OBSERVATION REPORT

Project: **Strata Plan LMS 280 – Chateau Comox** File No. S18-558
1272 Comox Street Report No. 10
Vancouver, B.C. Date: Aug 15, 2019

ITEM: Building Envelope Field Review

Photos No. 10.1 and 10.2

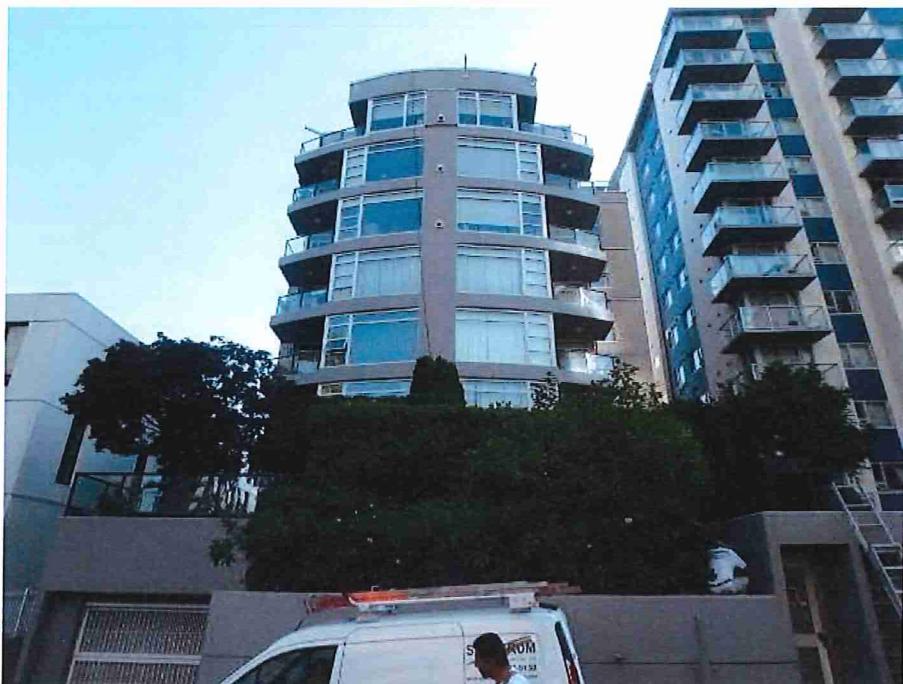
10.2	Painting and caulking work is nearly complete on the south elevation. The contractor has installed Dow Corning 123 Tape at all horizontal stucco expansion joints as required. The silicone tape spans across the vulnerable metal stucco expansion joint which had been observed to be rusty and failing on our condition review from last year. The lower edge of the silicone tape is provided with intermittent weeps which will allow any water which potentially gets behind to drain out. The tape is well installed over the uneven surface with no excessive bulging or wrinkling observed (Photos No. 10.1 to 10.3).

Photos No. 10.3 and 10.4

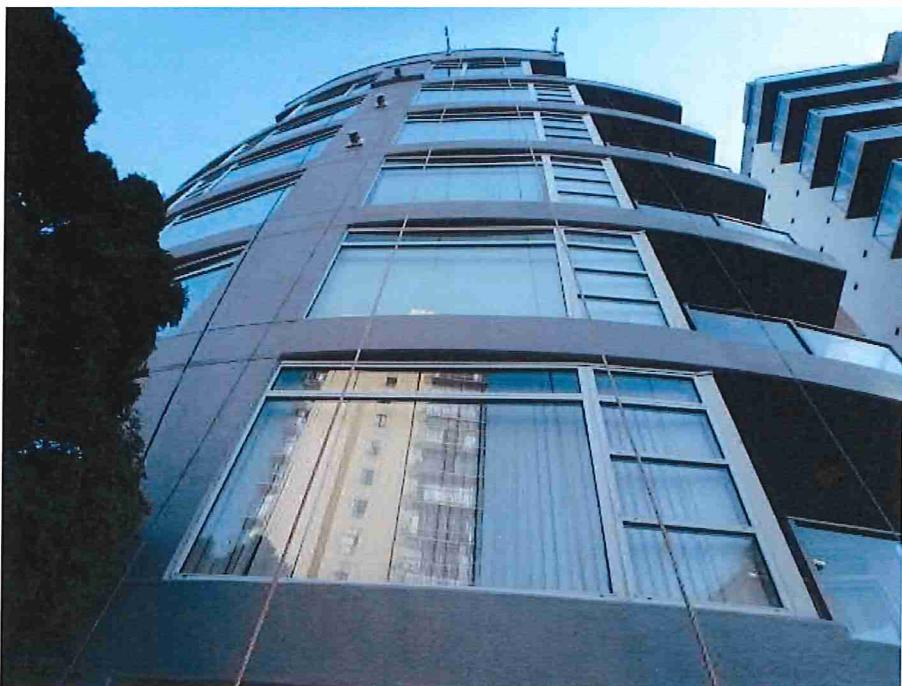
10.3	At the top of the drop, there are three fireplace vents, two of which are installed in original face sealed construction. Silicone 123 Tape is required at the head and jambs of the lower two vents (Photo No. 10.4).

Photos No. 10.5 and 10.6

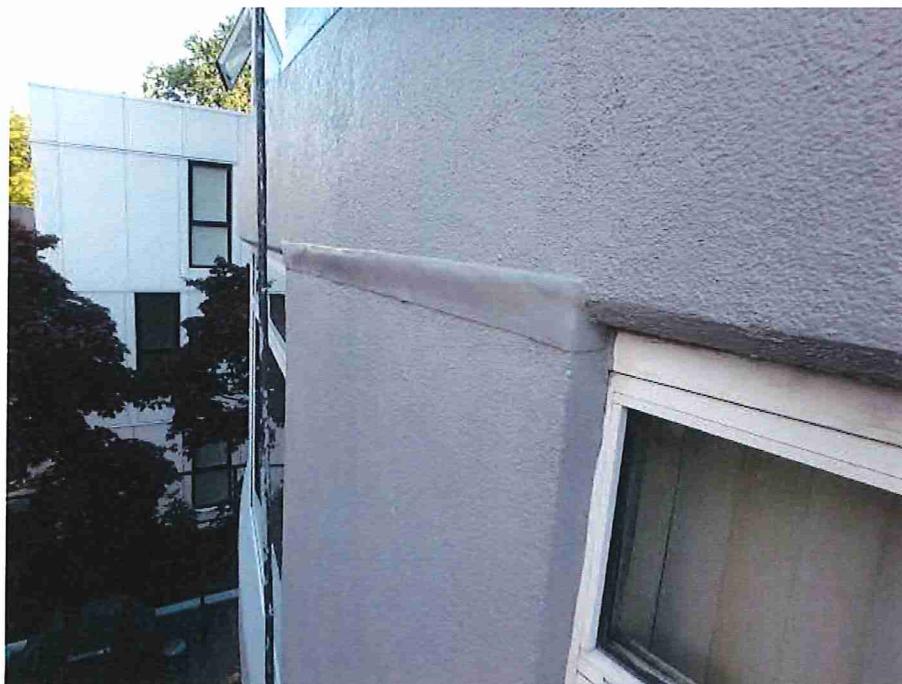
10.4	At the southeast corner of the drop, caulking replacement is also required at the vertical joint between the window frame and corner flashing. The existing caulking must be removed and replaced with new. SEE requested the contractor apply sufficient pressure and caulking so that the material is injected between the mating surfaces to provide strong adhesive bond (Photo No. 10.5).

10.6 At Suite No. 602, the membrane base coat has been reapplied to the balcony with good workmanship observed (Photo No. 10.8).

Photos No. 10.7 and 10.8

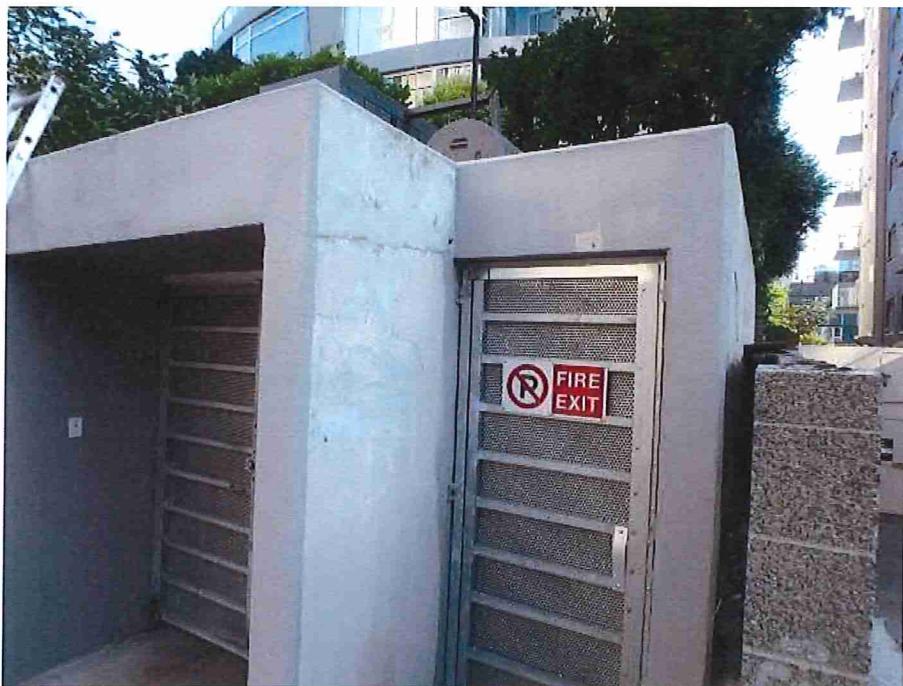
10.5 At Suite No. 702, acrylic stucco patching is required on the interior face and top horizontal surface of the balcony parapet (Photos No. 10.6 and 10.7).
